March 21, 2014

**Subject: Docket Nos. 50-361 and 50-362
Amendment Applications 266 and 251
Permanently Defueled Technical Specifications
San Onofre Nuclear Generating Station, Units 2 and 3**

FIGURE 3.7.18-1

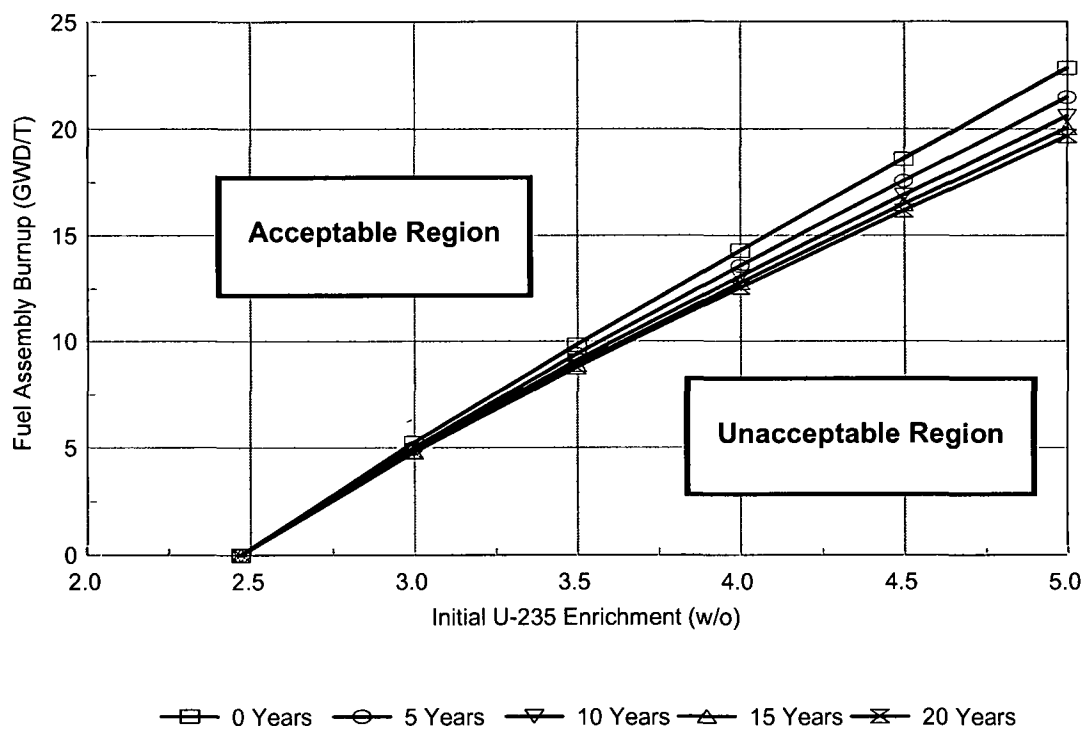
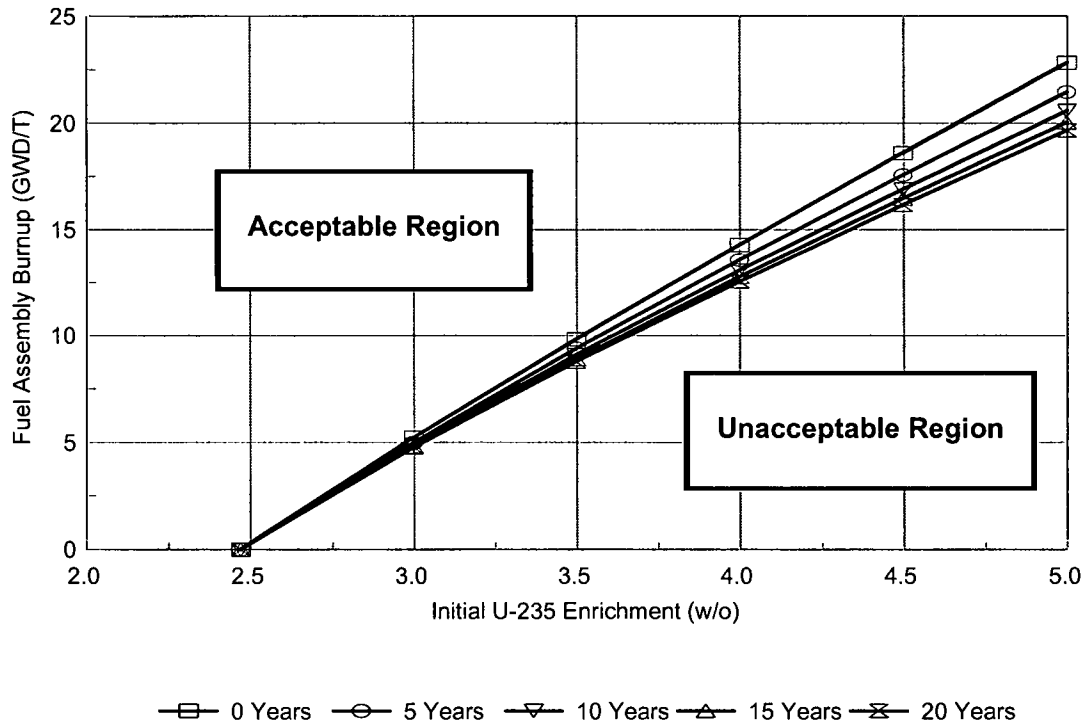
3.1.3-2 The combination of initial enrichment and burnup of each SONGS 2 and 3 spent fuel assembly stored in Region I shall be within the acceptable burnup domain of Figure 3.7.18-1 or Figure 3.7.18-2, or the fuel assembly shall be stored in accordance with Technical Specification 4.3.1.1. 3.1.3-1

Figure 3.1.3-1,
Figure 3.1.3-2,
Figure 3.1.3-3, and
Figure 3.1.3-4

- l. Units 2 and 3 fuel assemblies with a burnup in the "unacceptable range" of ~~Figure 3.7.18-1, Figure 3.7.18-2, Figure 3.7.18-3, and Figure 3.7.18-4~~ will be stored in compliance with Licensee Controlled Specification 4.0.100 Rev. 2, dated 09/27/07; and
- m. Each SONGS 1 uranium dioxide spent fuel assembly stored in Region II shall be stored in accordance with Licensee Controlled Specification 4.0.100 Rev. 2, dated 09/27/07.

FIGURE 3.1.3-1

FIGURE 3.7.18-3

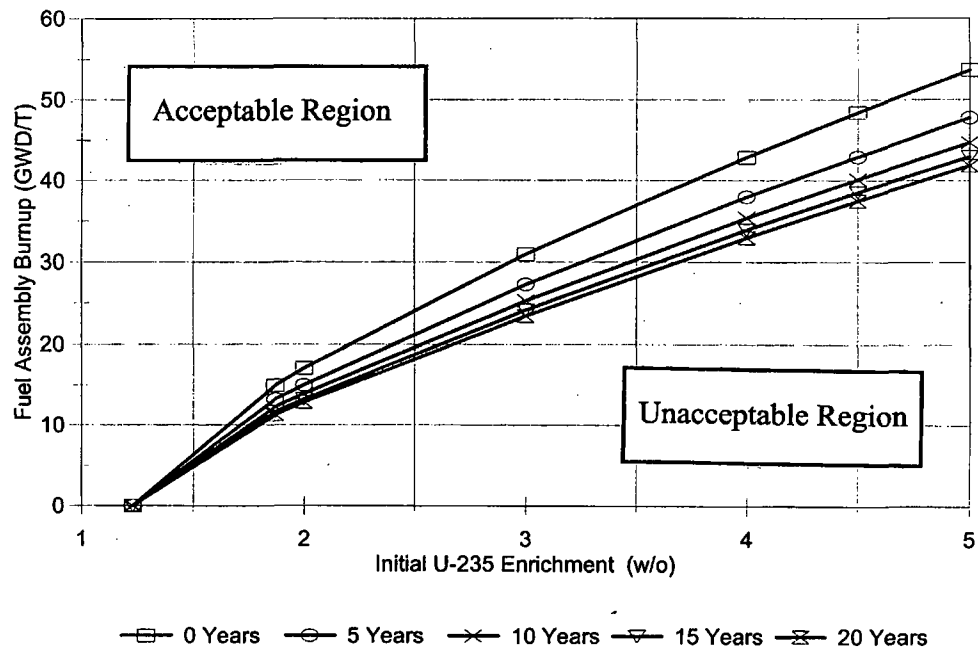
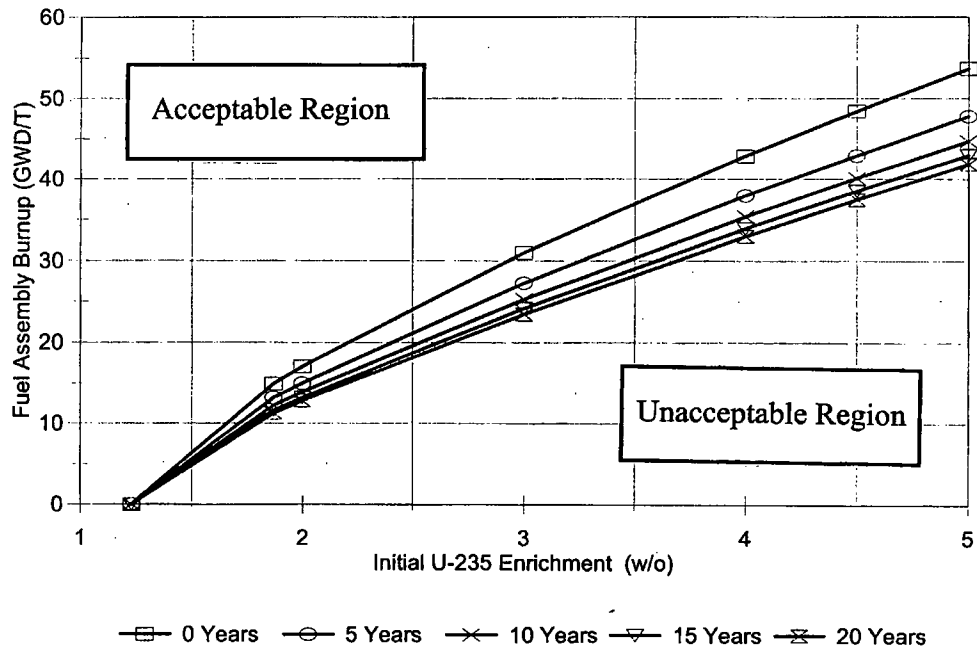
3.1.3-4 The combination of initial enrichment and burnup of each SONGS 2 and 3 spent fuel assembly stored in Region II shall be within the acceptable burnup domain of Figure 3.7.18-3 or Figure 3.7.18-4, or the fuel assembly shall be stored in accordance with Technical Specification 4.3.1.1. 3.1.3-3

FIGURE 3.1.3-3
